25 November 2011  
Ref BRI-LET-003

### **Review of Hydraulic Modelling**

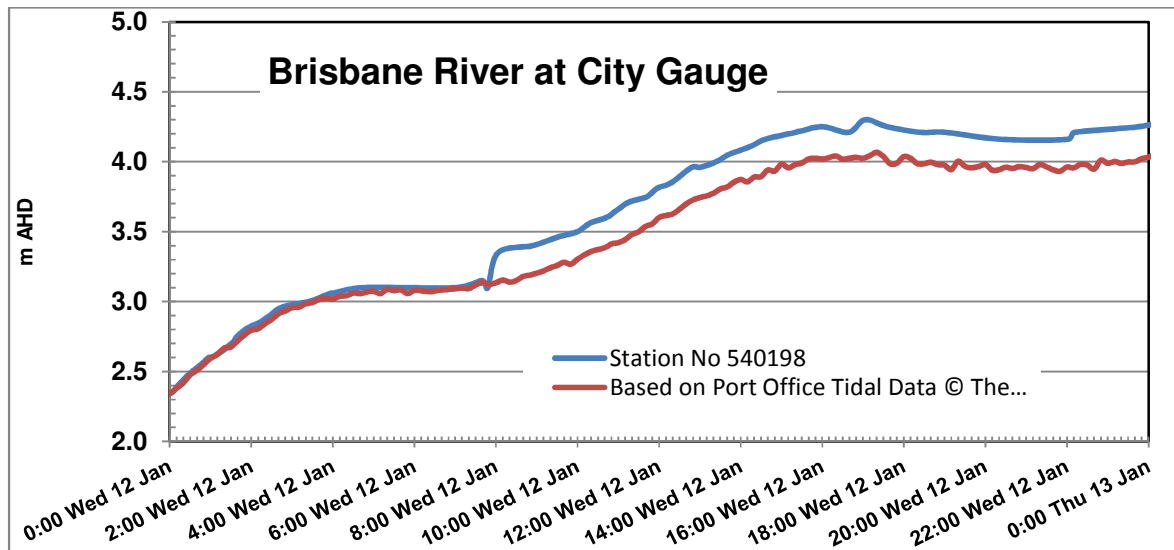
My comparison of the data from the two gauges over the period in question is shown in the plot below.

The above indicates that the gauge, Station Number 540198, experienced a displacement of approximately 250 mm between 07:48 and 08:09 Wednesday 12<sup>th</sup> January. Subsequently Station Number 540198 reported a river level approximately 200 mm higher than data provided by MSQ. Since gauge 540198 apparently records based on exceeding a particular change in level, it would seem that the displacement actually occurred close to the time of the recorded jump, i.e. 08:09 on Wednesday 12<sup>th</sup>.

The behaviour exhibited by the gauge Station Number 540198 is certainly not indicative of a natural event.

A potential source of discrepancy is that both pressure sensors are calibrated to the water density that they operate in. The density of the water in the Brisbane River during the flood could be expected to have varied from brackish to sediment laden fresh water. The MSQ gauge is apparently calibrated to salt water and it is unclear exactly how Station 540198 was calibrated.

However, depending on the zero for each of the gauges, a correction from clear fresh water to clear salt water would not be sufficient to explain a 200 mm displacement. In addition it is likely that due to the sediment load in the Brisbane River the water flowing past the sensors would have a density substantially higher than that of fresh water.
